**7000Acres**

Additional Submission from 7000Acres regarding matters raised during the examination that have not been resolved to their satisfaction.

**Tillbridge Deadline 6**

1<sup>st</sup> April 2025

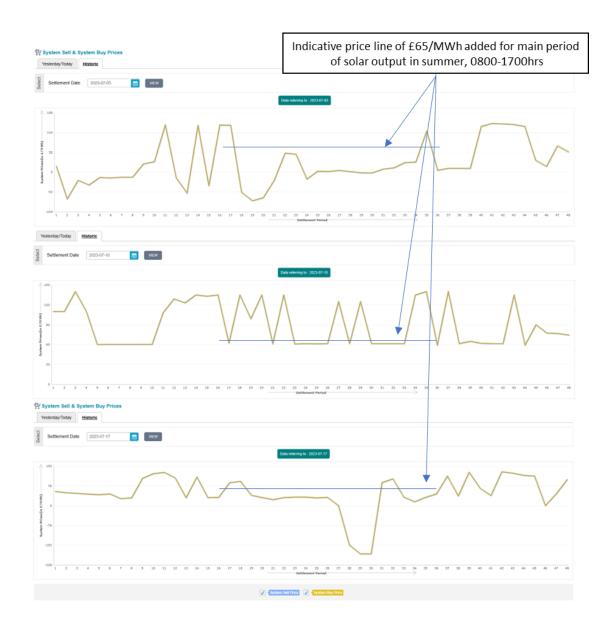
The graphs below are taken from BMReports<sup>17</sup> (website of the UK Electricity balancing and settlement market) and show the first three Mondays of July 2023 (Monday is chosen as this is frequently the highest demand day of the week) and show that system prices are frequently significantly lower than the indexed strike price. For 03/07, the price falls to £-75 per MWh, but hovers around zero for much of the peak solar output period. For 17/07, the price plummets to £-185 per MWh, and is around £22 per MWh for much of the peak solar output period. These figures demonstrate the relatively low spot market prices of electricity during periods when solar output is at its greatest, and the relatively high cost solar will be paid during these periods, through CfD prices.

Over the same period, the weekly average prices ranged from £115 per MWHr to £125 per MWhr (Electricity Prices: Forward Delivery Contracts, Weekly Average, from Ofgem) <sup>18</sup>, which provides an indication of the much higher cost of energy during periods at other times of the day, when solar is not able to contribute to the electricity system.

This demonstrates that, while the Applicant may argue the cost of deploying solar is low, <u>the value of when the bulk of solar energy is produced in the UK, is already when prices are among their lowest, and therefore this must be considered when weighing the benefits and impacts of large-scale ground-mounted solar installation.</u>
